**NOTICE OF PREPARATION OF A
DRAFT ENVIRONMENTAL IMPACT REPORT FOR THE
ALMADEN OFFICE PROJECT**

FILE NO: H19-004
PROJECT APPLICANT: BOSTON PROPERTIES
APN: 264-28-019, -022, -023, -024, -025, -028, -149, -152, -
153, -160, -167, -168, -169, -172, -173, -174, -175, and -
176

NOTICE OF PREPARATION OF AN ENVIRONMENTAL IMPACT REPORT FOR THE ALMADEN OFFICE PROJECT

FIGURE 6

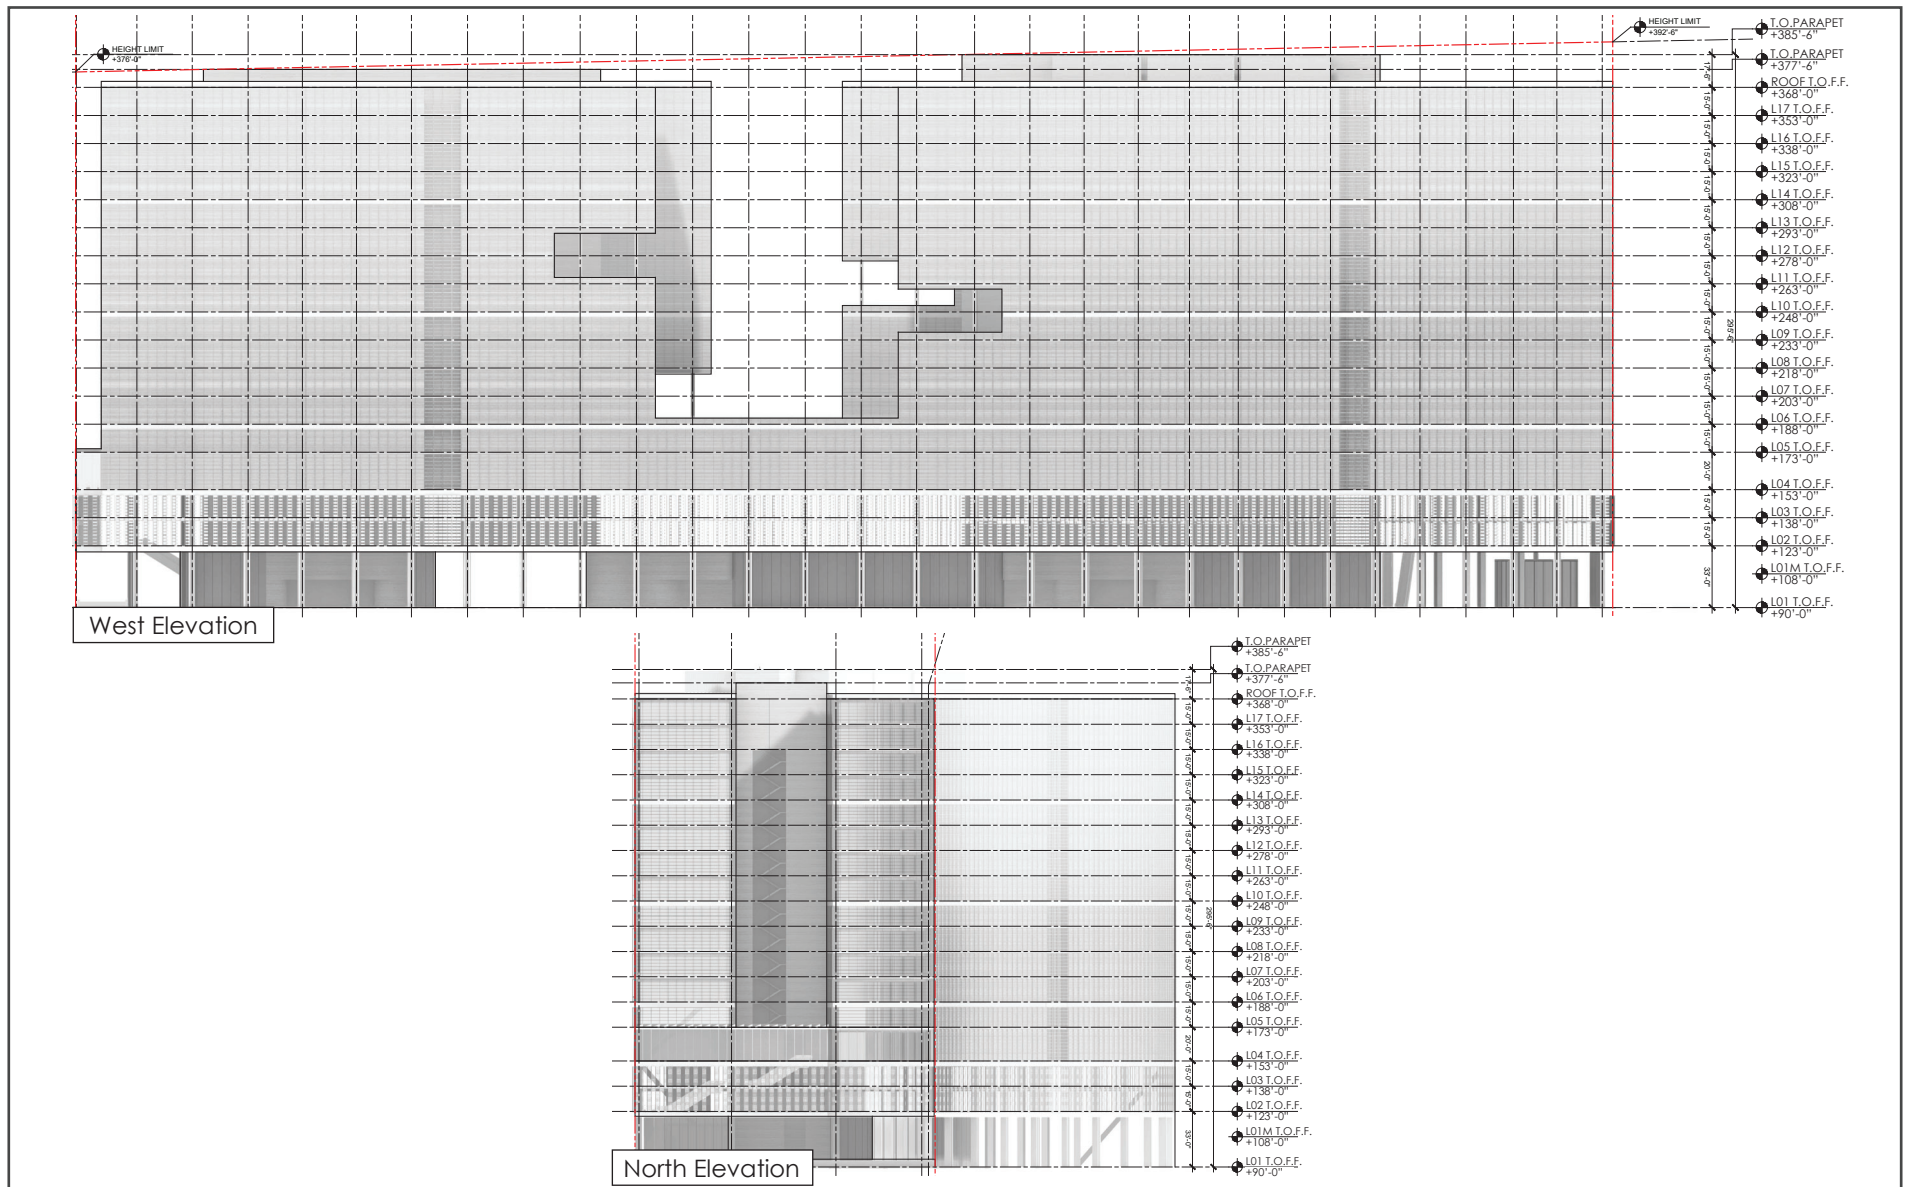
4. Figure 7 of the NOP appears to show a drive aisle on the ground floor between the trail and what we were told are the proposed ground-floor commercial uses within the central portion of the project. This is concerning for all of the previously described reasons and would effectively eliminate the trail’s Class I status. It would also affect trail users and would not allow workers to safely access the trail or Discovery Meadow on the west side of the river. It also would put the “back” of the project along the trail and Discovery Meadow – something we do not support. Too many Downtown structures were built this way which has significantly affected our ability to activate the parks along the trail. It should also be noted that the figure is inaccurately labeled. The view is not from Woz Way and does not look to the north.
